DOCUMENT 00 90 00
ADDENDUM

ADDENDUM No.: 3

RE: LAC DU FLAMBEAU CHILD DAYCARE CENTER
ADJACENT TO 13708 YOUTH CTR LN (TO THE SOUTH)
LAC DU FLAMBEAU, WISCONSIN 54538
PROJECT NO. 22066

C100

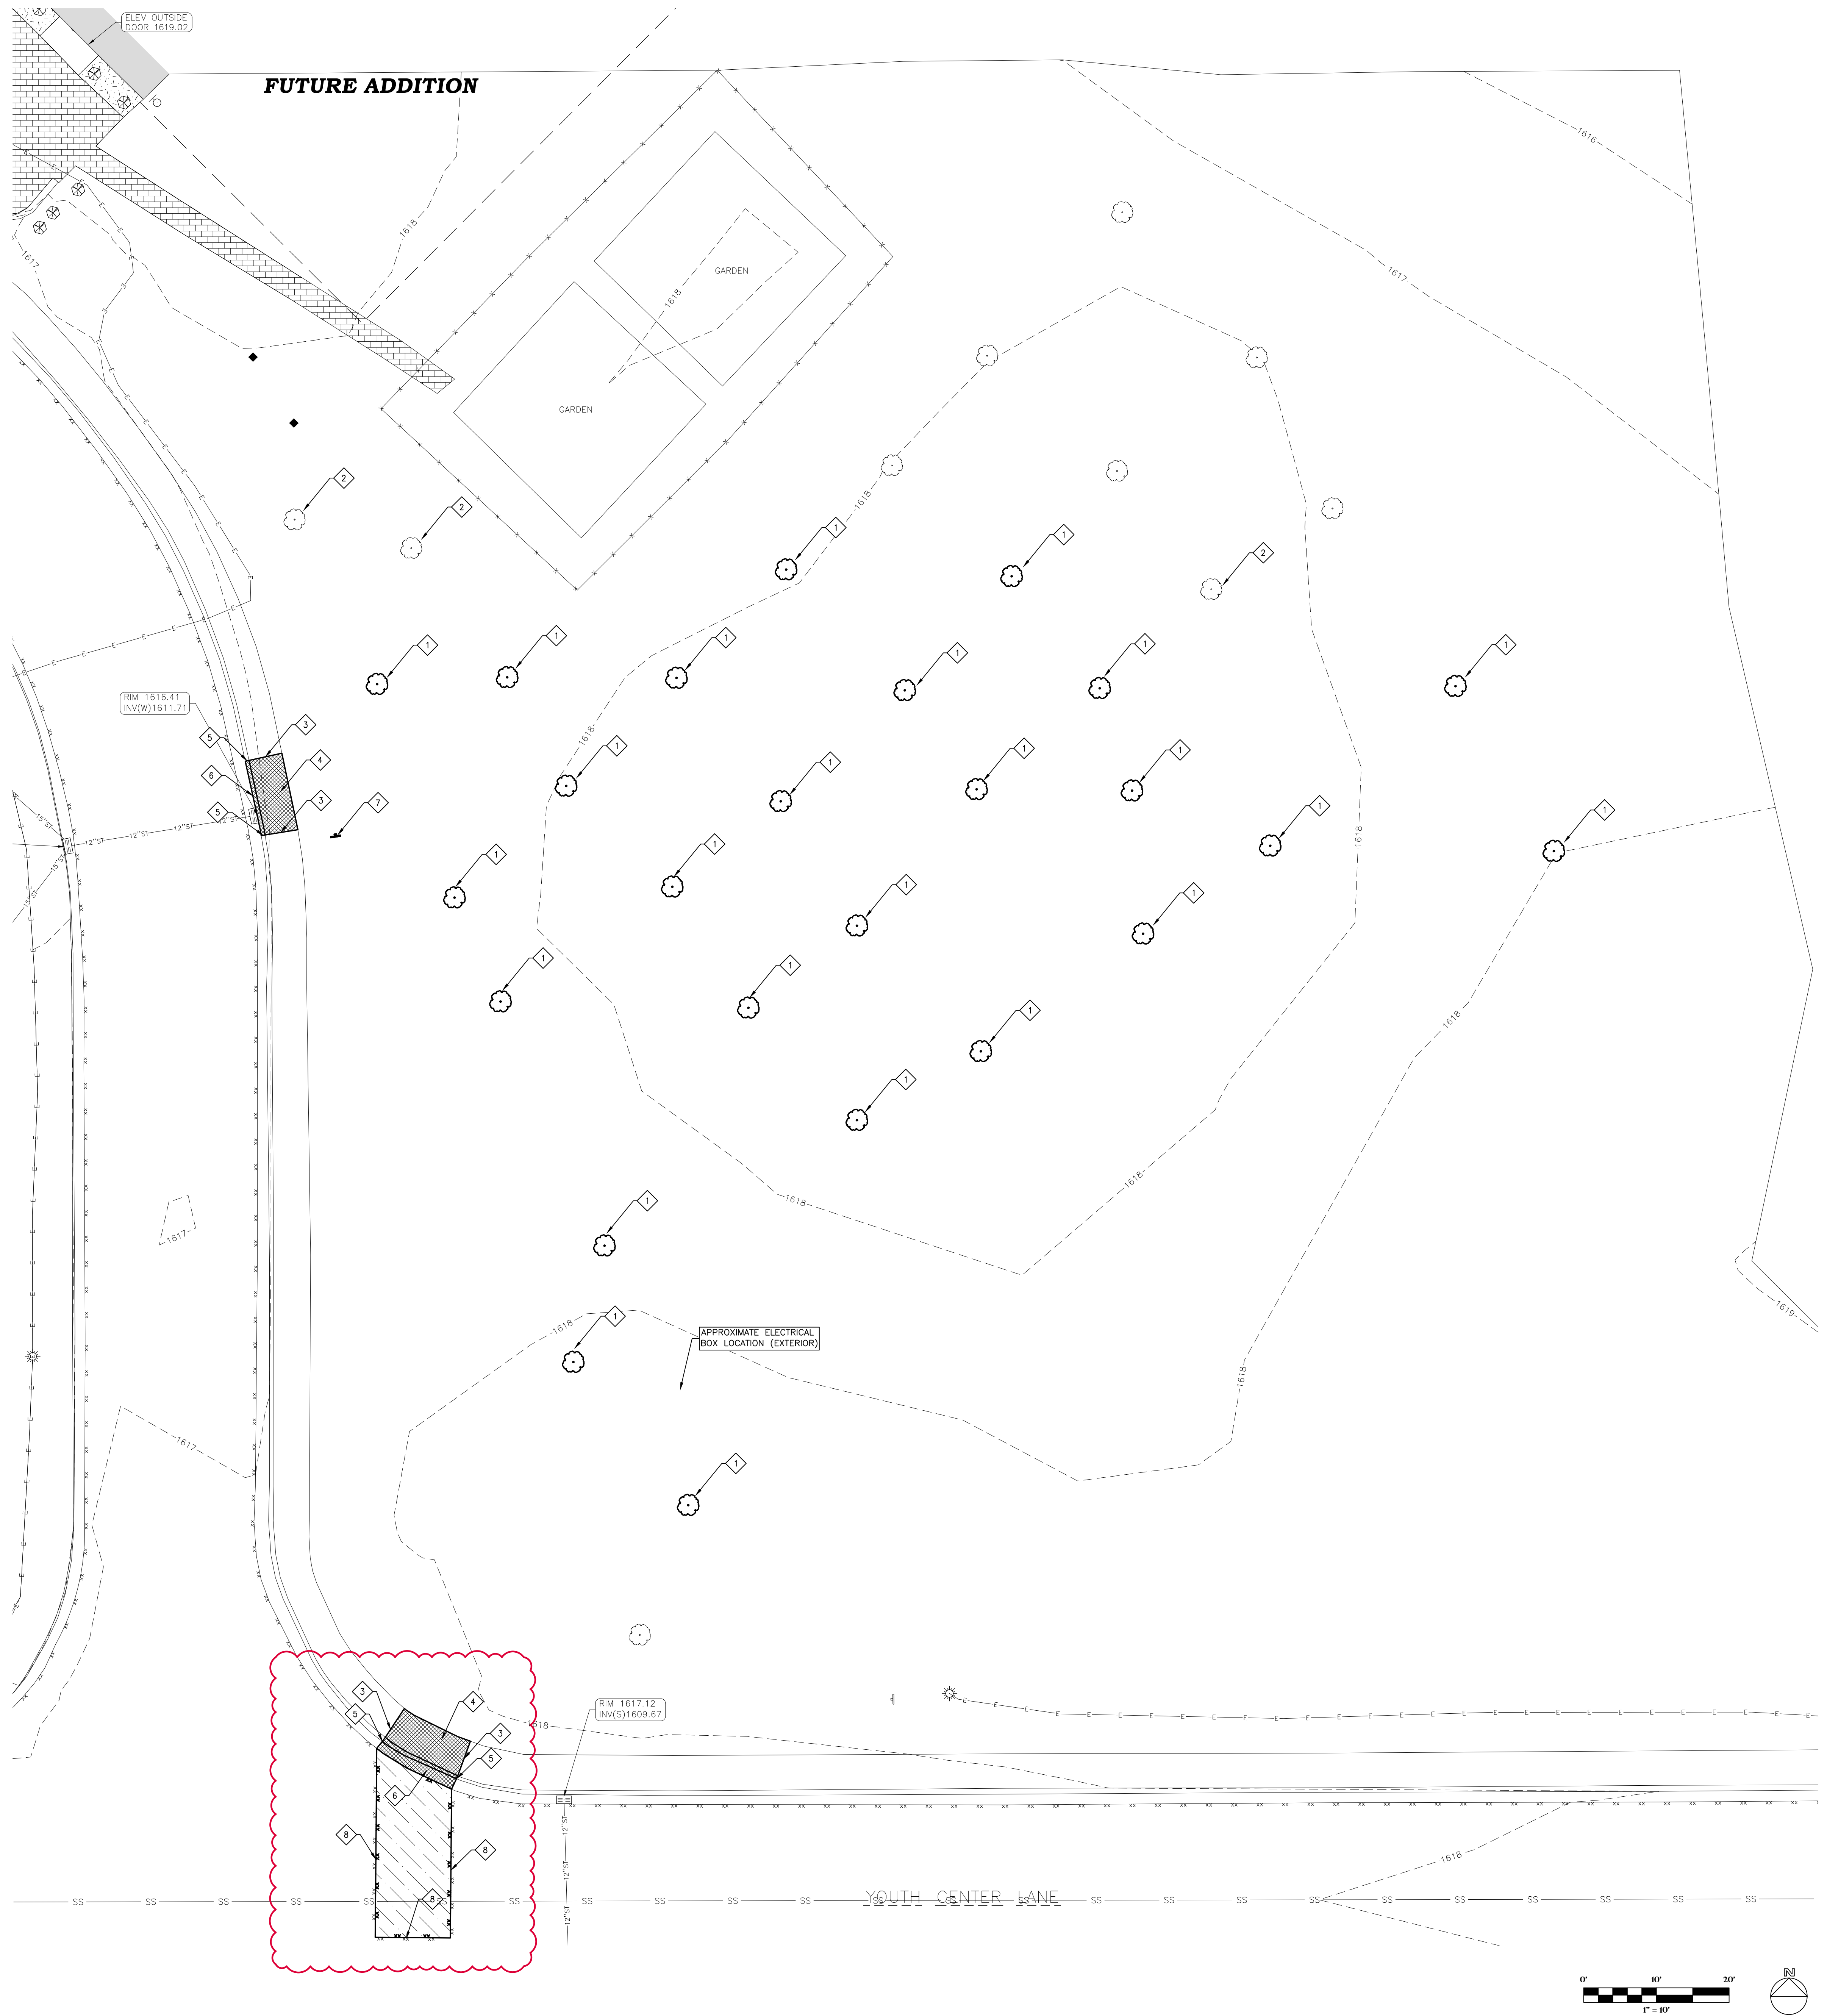
4. Sheet C100 DEMOLITION PLAN 30"x42"
 - a. See the revised sheet included in this addendum. Disregard the previous version.
 - b. Added paving removal for utility changes shown elsewhere in this addendum.

C101

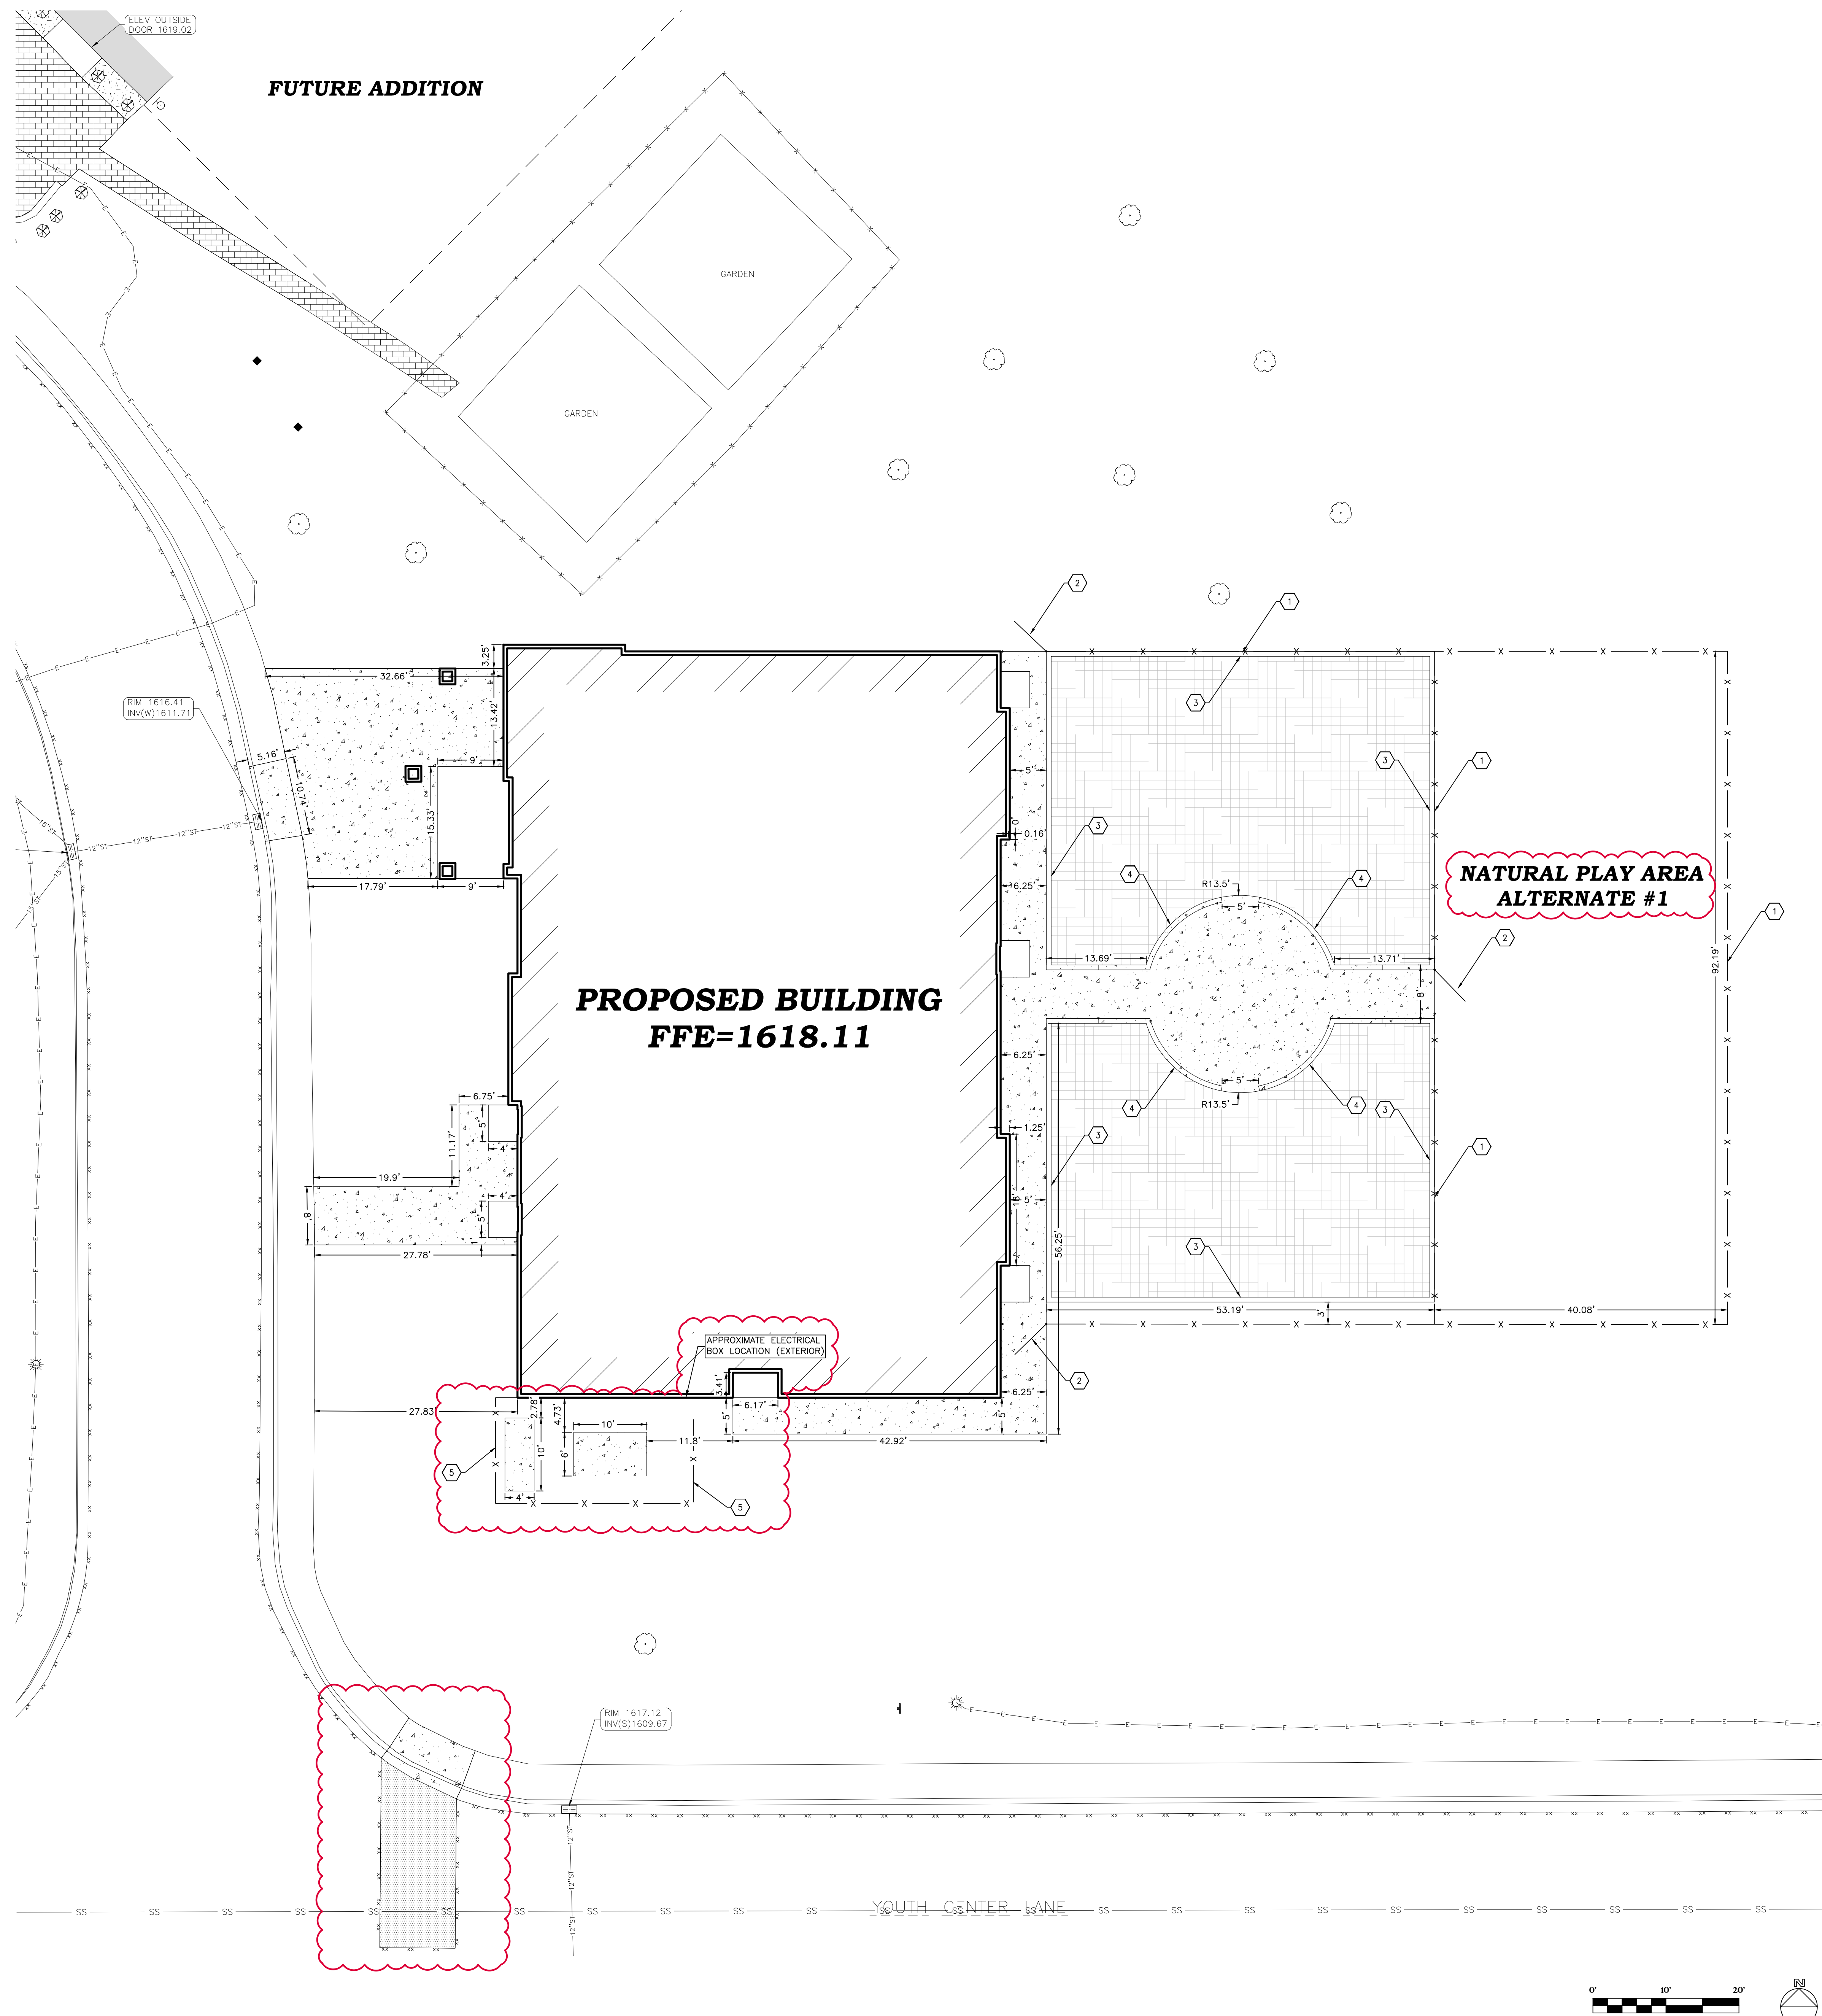
- c. Added sheet C105 to the index.
5. Sheet C101 LAYOUT PLAN 30"x42"
 - a. See the revised sheet included in this addendum. Disregard the previous version.

- b. Added label for "Natural play area alternate #1".
 - c. Added concrete pad for mechanical equipment and reshaped plastic fence.
 - d. Added a reference to a detail for keynote item 3.

- e. Added paving replacement for utility changes shown elsewhere in this addendum.
6. Sheet C102 GRADING PLAN 30"x42"
 - a. See the revised sheet included in this addendum. Disregard the previous version.

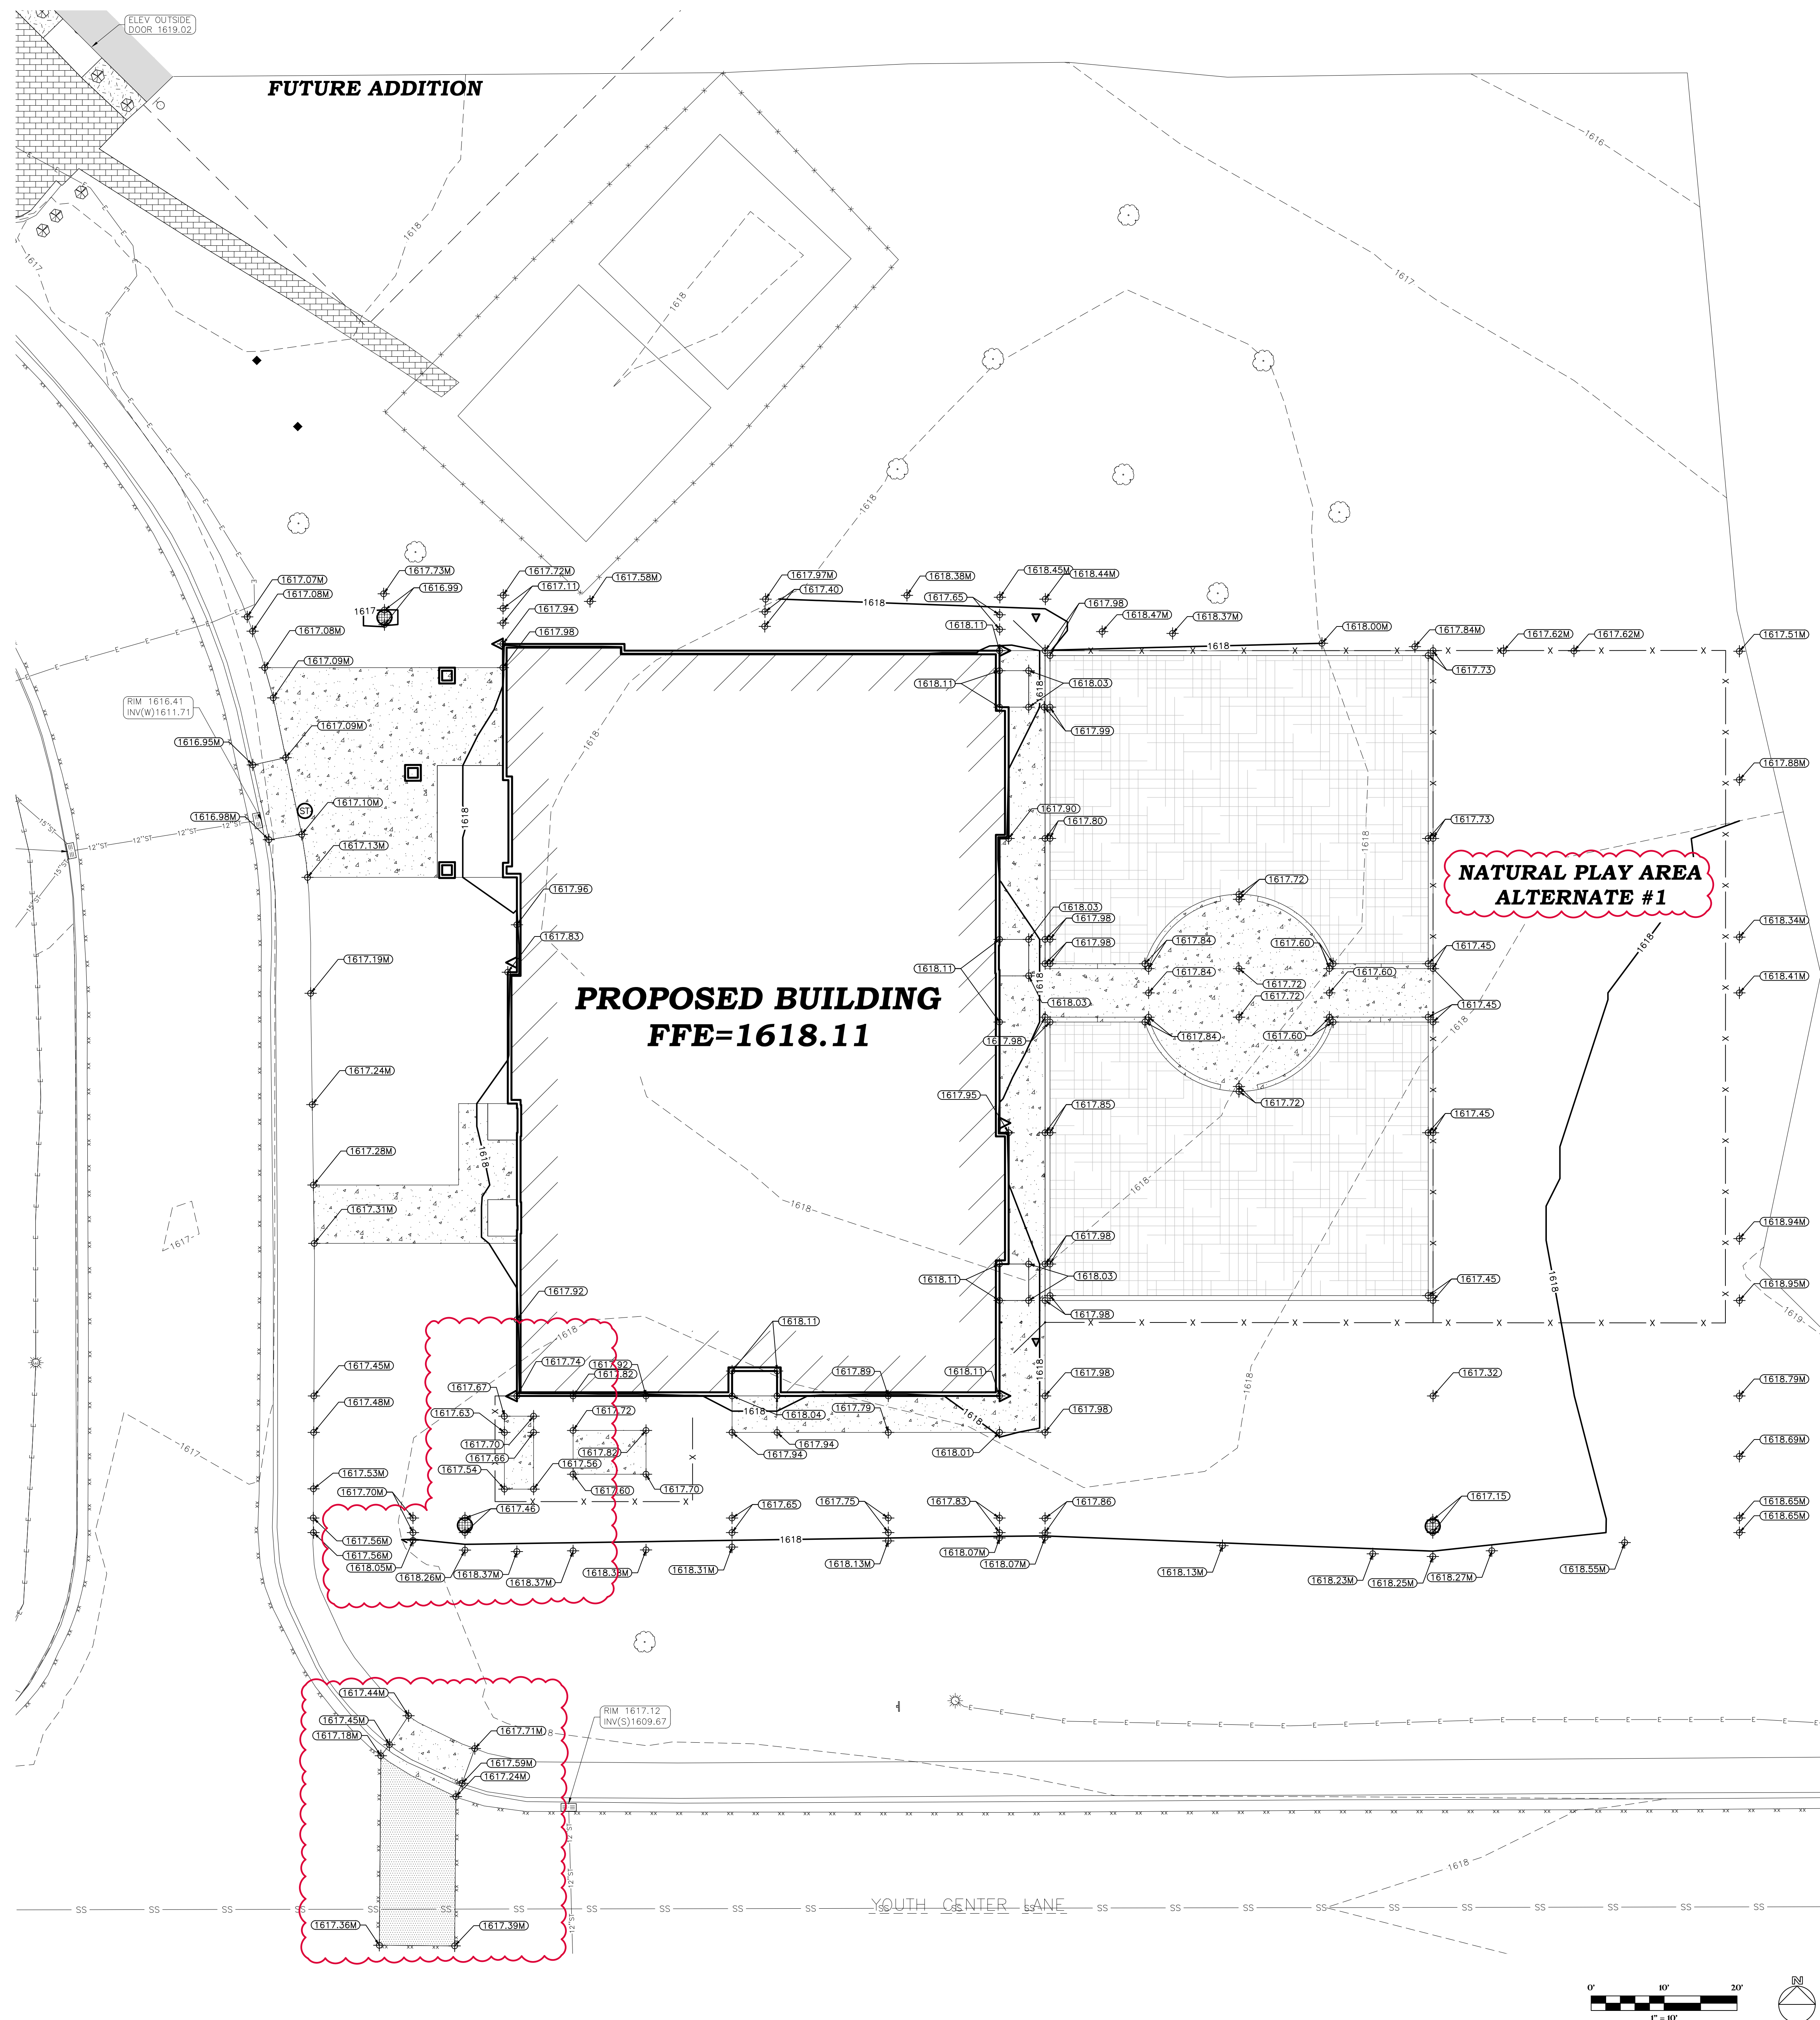
- b. Added label for "Natural play area alternate #1".
 - c. Revised elevations at added concrete pad and added elevations at paving.
7. Sheet C103 EROSION CONTROL PLAN 30"x42"
